Servend® Parts & Service Communicator

Subject: Ice Flow Restrictor

Figure 4

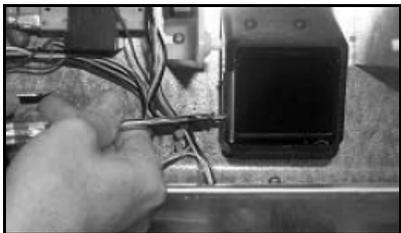
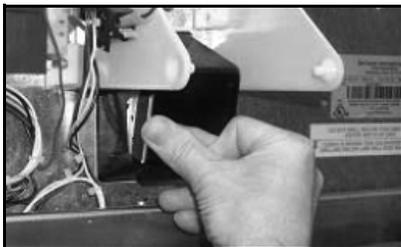
In a continuous effort to improve our equipment Manitowoc Beverage Equipment has made a small change to the M/MD/S/SV/SVi Ice Flow Restrictor Kit. This kit is now supplied with two 1/8" screws rather than the two 1/4" screws previously used to secure the restrictor to the chute of the dispenser. This change was made to assure the screws would not interfere with the movement of the rocking chute assembly. This bulletin was also created to show technicians what a correctly bent ice flow restrictor will look like from the factory. If the restrictor is bent incorrect it can be corrected by simply pinching with a pair of pliers until the bent part is parallel with the main body of the restrictor. See example to the left.

1. Unplug the dispenser.
2. Remove merchandiser, rocking chute, rocking chute door and door lock from the dispenser.
3. Remove the screws from the ice flow restrictor.
4. Slide the ice flow restrictor into the left side of the dispenser chute with the fold fitting over the left side of the chute.
5. Firmly press the restrictor into the chute to bottom out at the fold.
6. Replace setscrews on the left side of the restrictor, indenting the tip of the screw into the side of the plastic chute.
7. Replace the parts previously removed in step number 2.
8. Plug the dispenser in.
